Tanker Q&As and CIs on the IACS CSR Knowledge Centre

# CI-T 7 Application of the Common Structural Rules for Double Hull Oil Tankers

(November 2009)

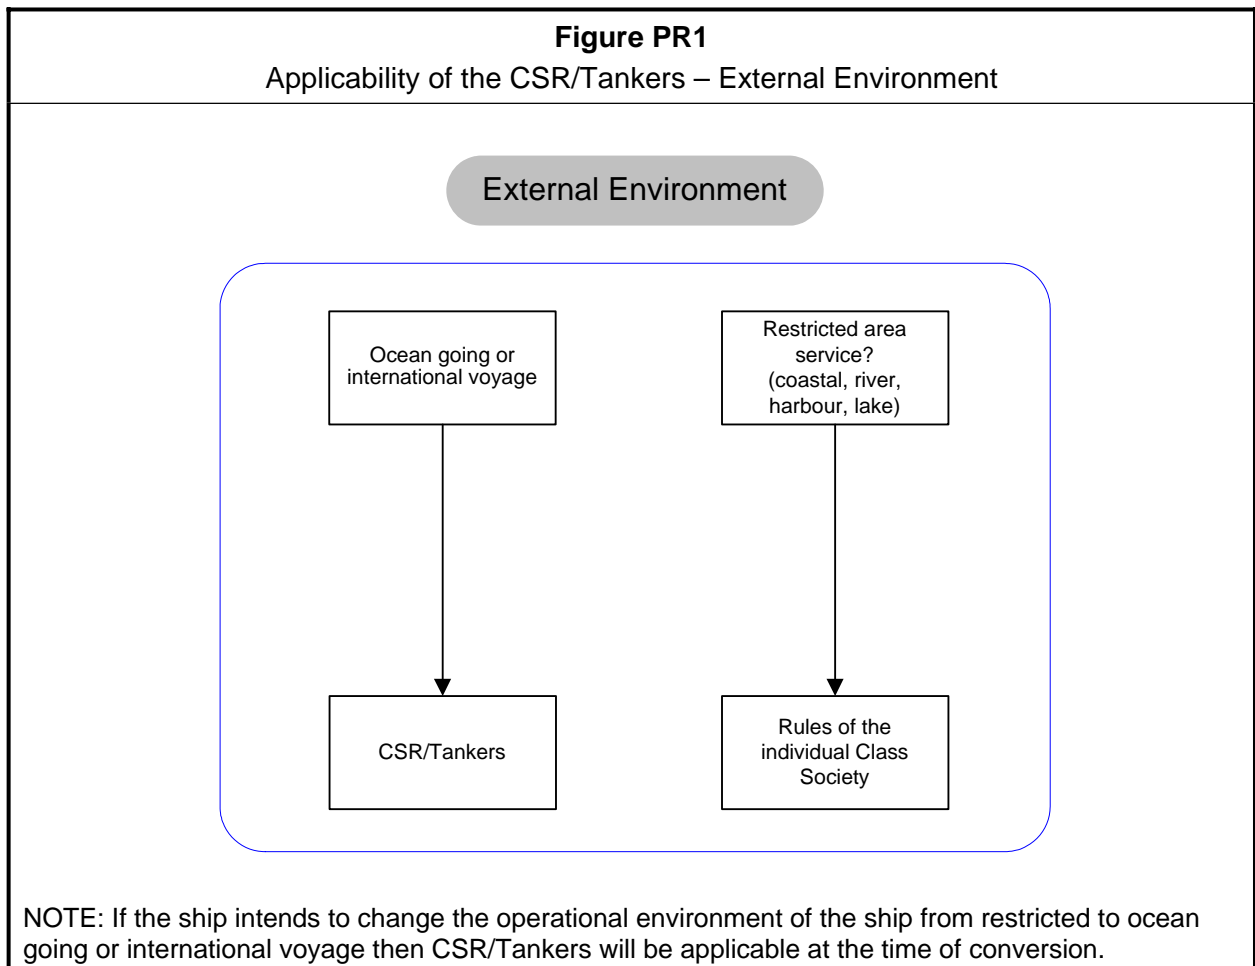
Because there is uncertainty about the actual trading patterns of most ships, it is necessary to choose an arbitrary, but prudently severe, wave environment for the purposes of design assessment. The Rule requirements are therefore based on a ship trading for all of its life in the demanding North Atlantic wave environment. See Figure PR1 for application of CSR/Tankers based on external environment.
